Section 16 Planning Application for Proposed Minor Relaxation of Building Height Restriction for Permitted Flat Use at TMTL 569, Tuen Mun, New Territories (Application No. A/TM/604)

Updated Planning Statement

Response to Comments and Supporting Attachments

Checked		Drawn	
Rev		Date	
Scale		Figure	3.1

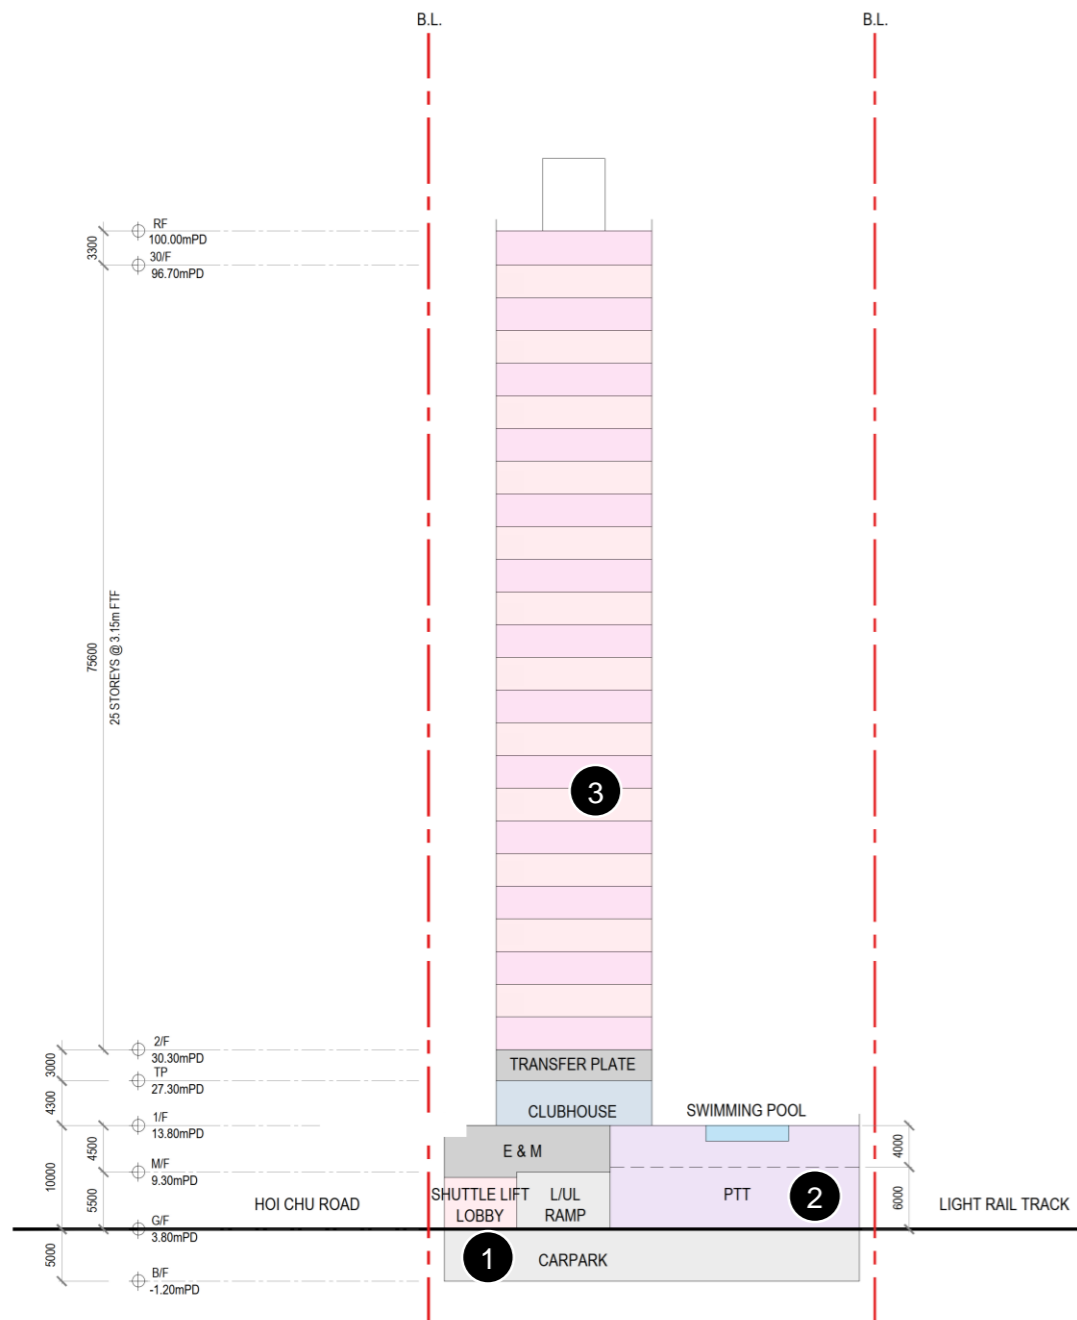
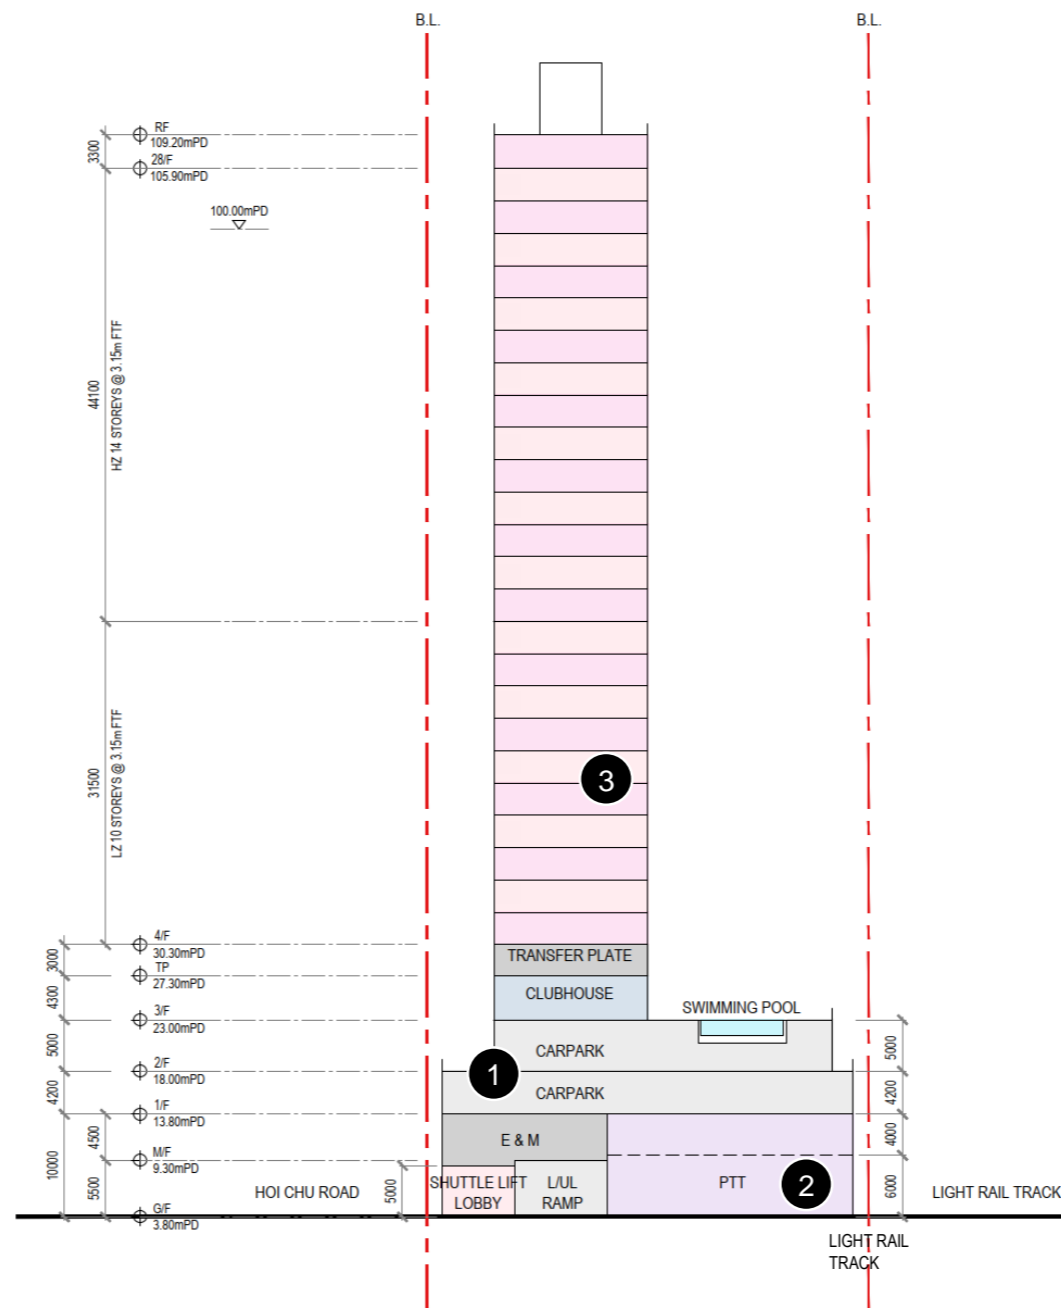
Departmental Comments	Responses to Comments
1.4	<p><u>Para 3.3.2:</u> Please elaborate with plans why “the car park levels have to accommodate various uses, such as E&M uses”.</p>	<p>Please understand that the Subject Site is elongated in configuration and subject to various design constraints and considerations. The podium footprint is subject to various non-building areas and building separation requirements under Lease and Sustainable Building Design Guidelines (PNAP APP-152). A large portion of G/F also has to be occupied by PTT. To optimise the usage of floor space, it is necessary to co-design and integrate essential E&M facilities serving the PTT and the residential development across different levels at the podium (i.e. including the car parking floors). Detailed design considerations will be depicted in Item 1.9 and 1.10 below.</p> <p>To help understanding various E&M rooms at podium levels, their respective names are now highlighted on the floor plans. Please refer to Attachment A – Updated Scheme for consideration.</p>

Departmental Comments	Responses to Comments
1.9	<p><u>Figure 3.3, Design Consideration #2</u>: Please demonstrate with plans and elaborate in detail how the car ramp would affect the provision of E&M of the PTT. Please explain why the floors for E&M and carpark cannot be switched to avoid the potential impact of the car ramp that is purported to be occupying the space on E&M floor.</p>	<p>Please understand that the proposed development is not a solely private residential development, but with provision of a PTT as required under Lease. With respect to the design requirements of the PTT, minimum width for two-way traffic of 5.5m; and desirable gradient for car ramp of 1:10, a longer and more sizeable vehicular ramp has to be provided for leading the vehicles from the ingress / egress at Hoi Chu Road to the car parking floors at the floors above the PTT.</p> <p>To facilitate subsequent handover of the PTT for relevant Government authorities' operation and maintenance, plant rooms serving the PTT and the subject residential development have to be physically separated against each other as far as practical. For instance, all essential plant rooms have to be provided at-grade and at the M/F in close proximity to the PTT. Switching the E&M floors with the car parking floors above will lengthen the servicing channels connecting the plant rooms and the PTT, which is considered undesirable in terms of space and cost efficiency.</p>

1.10	<p><u>Figure 3.3, Design Consideration #3</u>: Please demonstrate with plans and elaborate in detail why the one level basement car park under the approved GBP Scheme will need to be spread across two levels at aboveground under the proposed development.</p>	<p><u>Basement Car Park Scheme (i.e. Approved GBP)</u> With basement carpark design, area for car park spaces can be optimized at basement floor because no E&M facilities were provided at basement. Also with consideration of minimizing the environment nuisance and time cost of site excavation, only 1 level of basement was proposed and it was able to accommodate the 70 nos. car parking spaces as required under Lease.</p> <p><u>Aboveground Car Park Scheme (i.e. Current Proposed Scheme)</u> In comparison, the area available for aboveground car park is constrained and 2-storey car park levels are required. The current S16 scheme is considered optimal due to the below design considerations:</p>

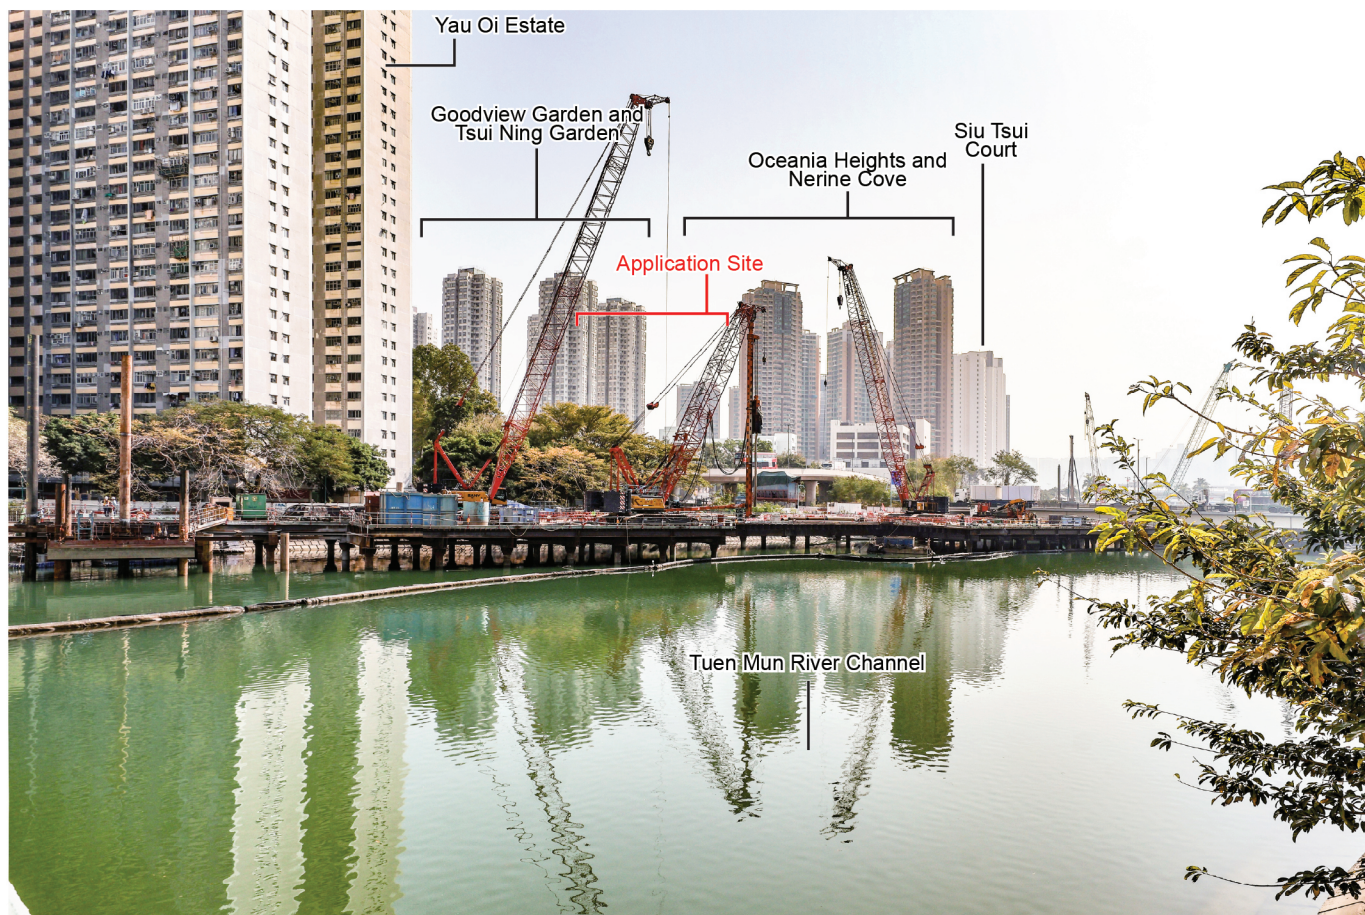
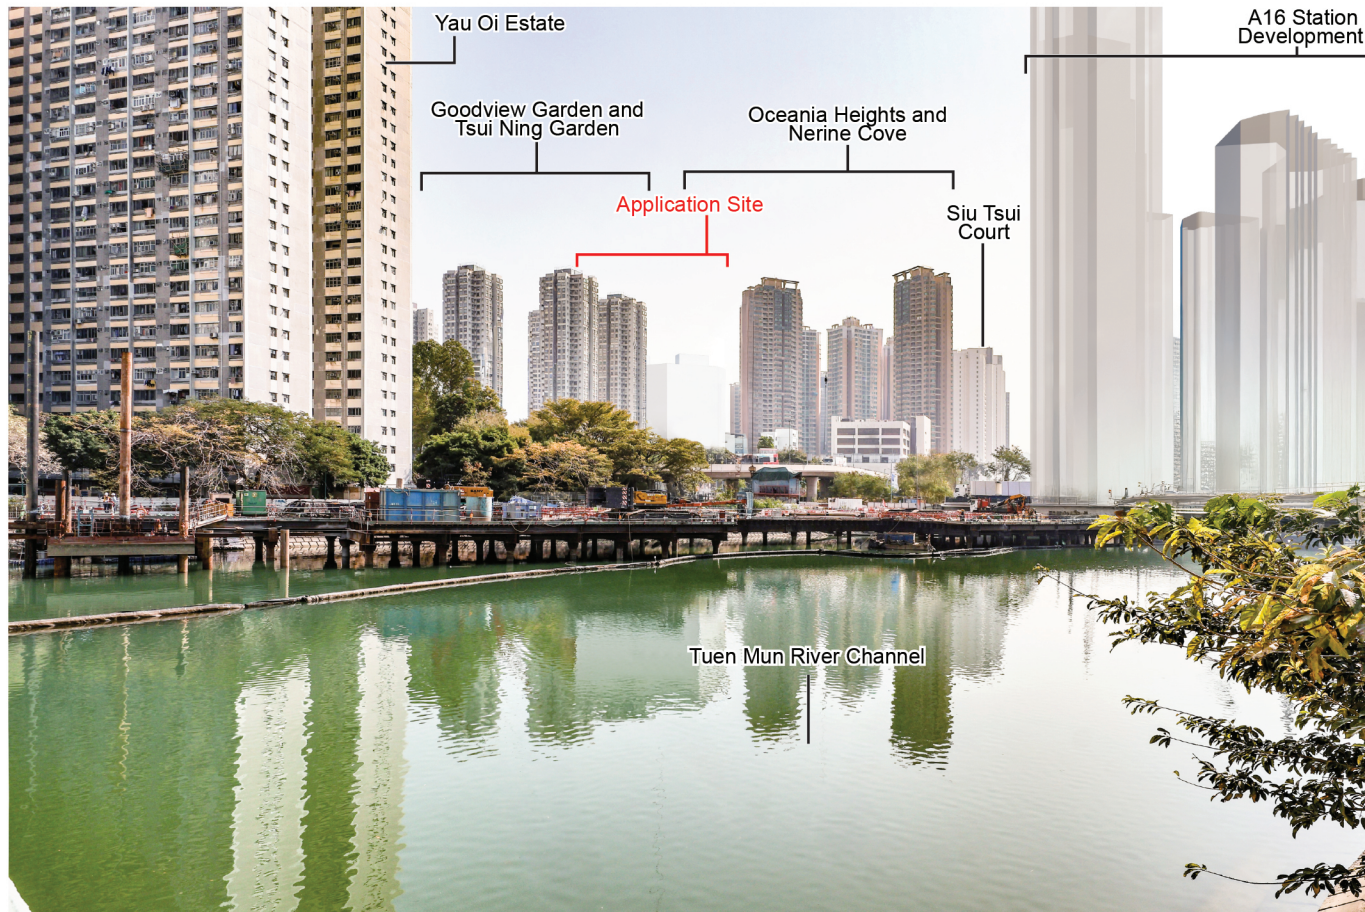
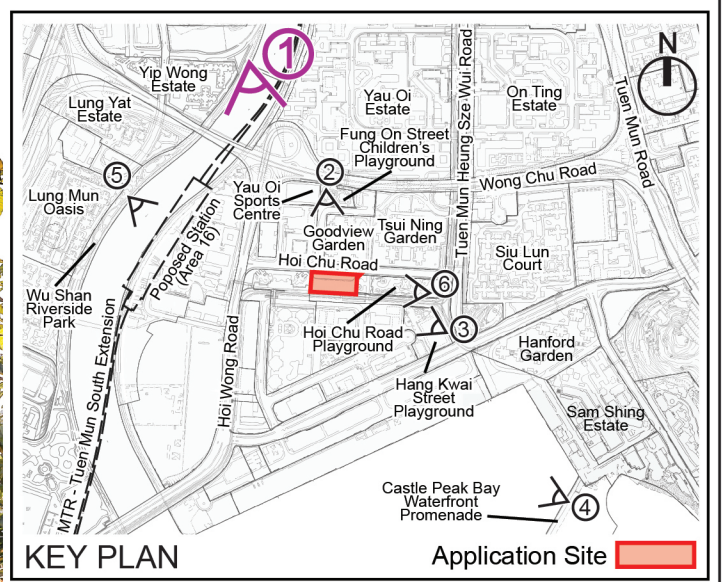
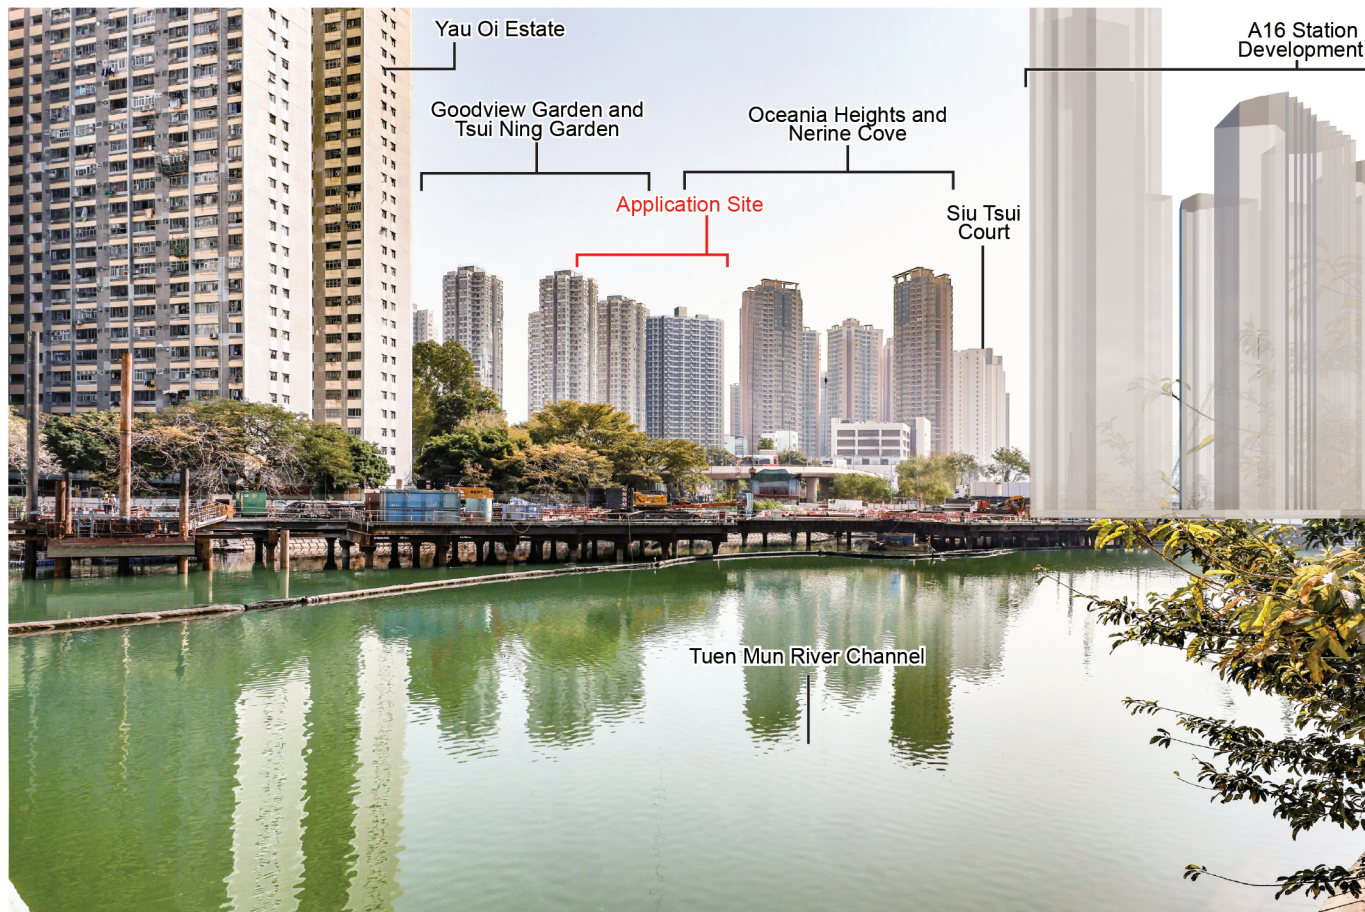
2.4	<p>VP 1 (figure 4.1) – the proposed development appears to be taller (i.e. appears to be level with Goodview Garden) and half of the proposed development should be screened by Goodview Garden and Tsui Ning Garden at the foreground in the photomontage. In view of the slight visual obstruction to the open sky view, the overall visual impact of VP1 should be <u>Slight</u> instead of <u>Negligible / slight</u>.</p>	<p>Under the current updated scheme, the proposed building height will be reduced from 117.6mPD to 109.2mPD. At VP1, the proposed development will have a comparable height as the adjacent building cluster. A majority portion of the proposed development would also be screened by Goodview Garden and Tsui Ning Garden at the foreground. The overall visual impact of VP1 has been amended to slight.</p>

Open Space Demarcation Plan

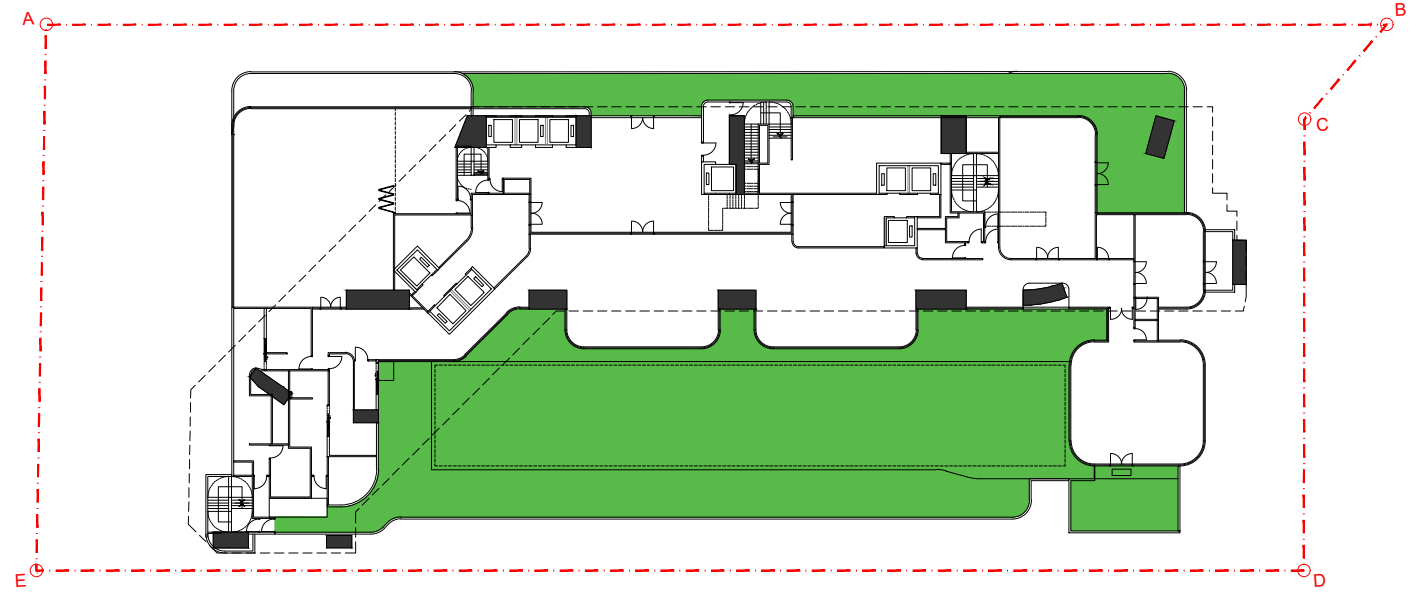
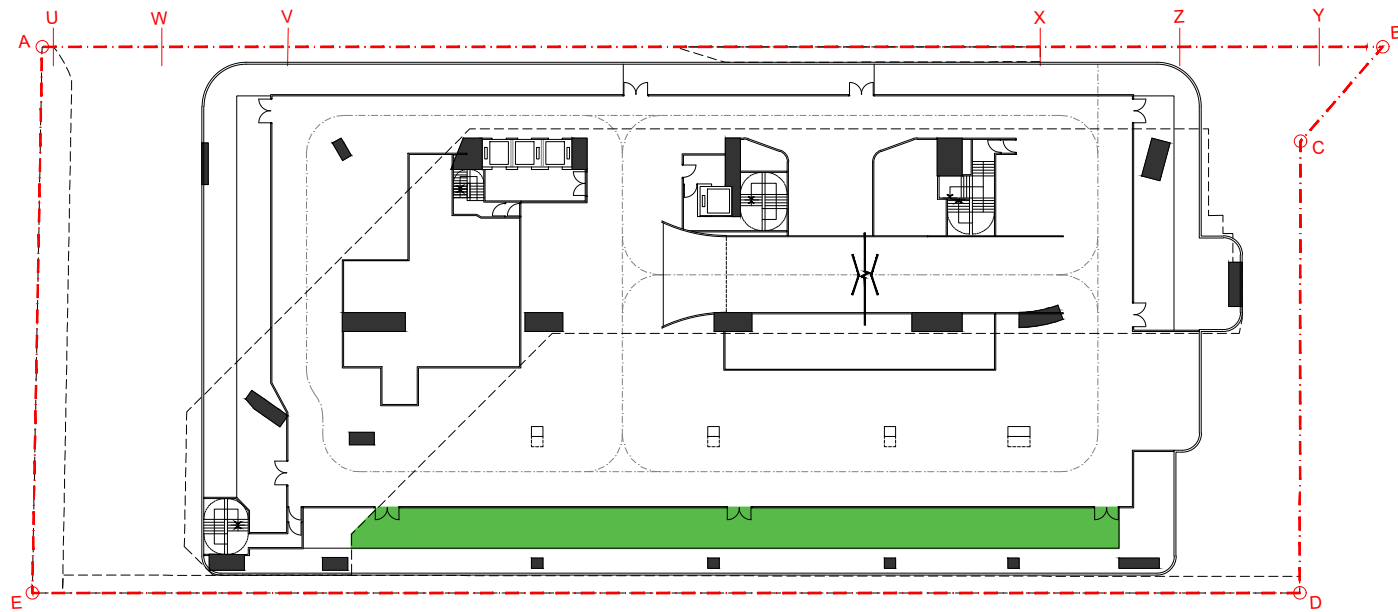
Departmental Comments	Responses to Comments
	<p><u>Specific Comments</u></p> <p>1.2 Please demonstrate with a plan whether the local open space of 1m² per person is achievable after removing the sky garden-cum-refuge floor at the proposed development.</p> <p>1.3 <u>Para 3.1.3 and Figure 3.2:</u> Please explain the rationale for providing 4 separate ingress / egress points. Please indicate on the figure the locations of the 2 double-width bus bays and the 1 single-width bus bay.</p>	<p>Under the current proposed scheme, 1m² per person of local open space serving the residents can be provided. Please see Attachment B – Open Space Demarcation Plan.</p> <p>Due to the site configuration with only 1 street frontage facing Hoi Chu Road, the rationale of providing 4 separate ingress / egress points are as below:</p> <ul style="list-style-type: none"> • The site is elongated in configuration. PTT is required to be provided. Vehicular flows and directions of PTT traffic and development traffic have to be provided with respect the locations of XYZ and UVW under Lease; • The design of 4 separate ingresses / egresses aligns with the indicative schematic layout in support of the OZP amendment of the Subject Site into “Residential (Group A)29” before land sales in Year 2024. Such schematic layout with 4 separate ingresses / egresses was subsequently incorporated into the Lease; • From road safety perspective, it is the common practice to provide separate “ingresses” and “egresses” for development traffic and PTT. It will ensure a safe and smooth operation of the PTT by avoiding traffic other than franchised services entering the PTT; <p>Please see Attachment C – Reference Material from OZP Amendment and Lease for reference. The locations of the double-width bus bays and single-width bus bay are annotated on the revised G/F plan (please see Attachment A – Updated Scheme). Please understand that the PTT detailed internal layout is subject to ongoing liaison and approval by respective Government department(s).</p>

OPEN SPACE AT R/F = about 524.459 sqm.

OPEN SPACE AT 3/F = about 1076.691sqm.

OPEN SPACE AT 2/F = about 148.850 sqm.
